# **Core Operating Limits Report**

**Dresden Station**

**Unit 2**

**Cycle 17**

FIGURE 2.2-1

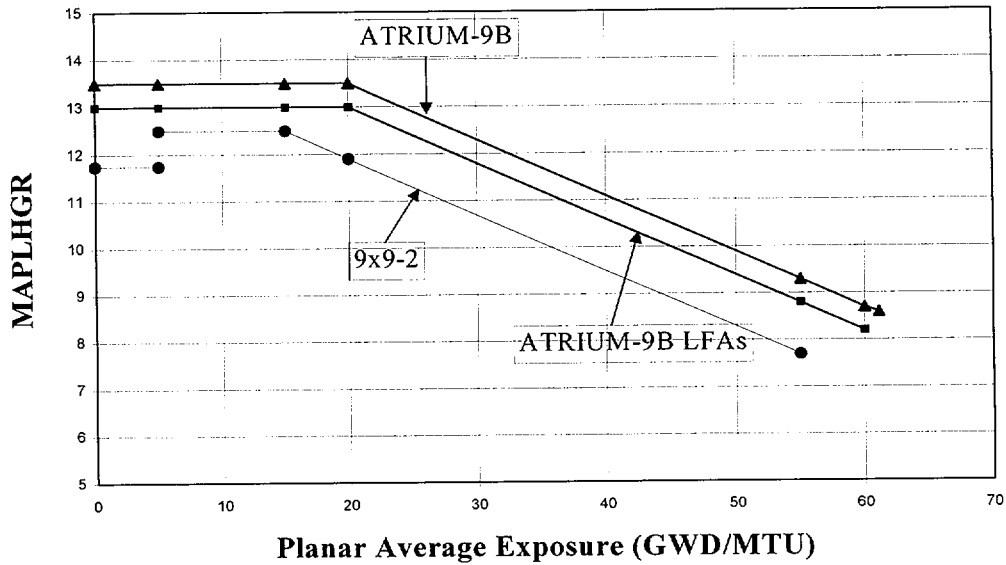
| Affected Section | Affected Pages | Summary of Changes   | Date     |
|------------------|----------------|--|----------|
| Figure 2.2-1     | 2-2            | Figure 2.2-1 and the table below the figure were revised to reflect how the limits are implemented into the core monitoring code <sup>1</sup> .  | 10/12/99 |

<sup>1</sup> Powerplex can not implement a step change in an operating limit. Therefore, the COLR was revised to reflect a conservative implementation method for use in the Powerplex input deck.
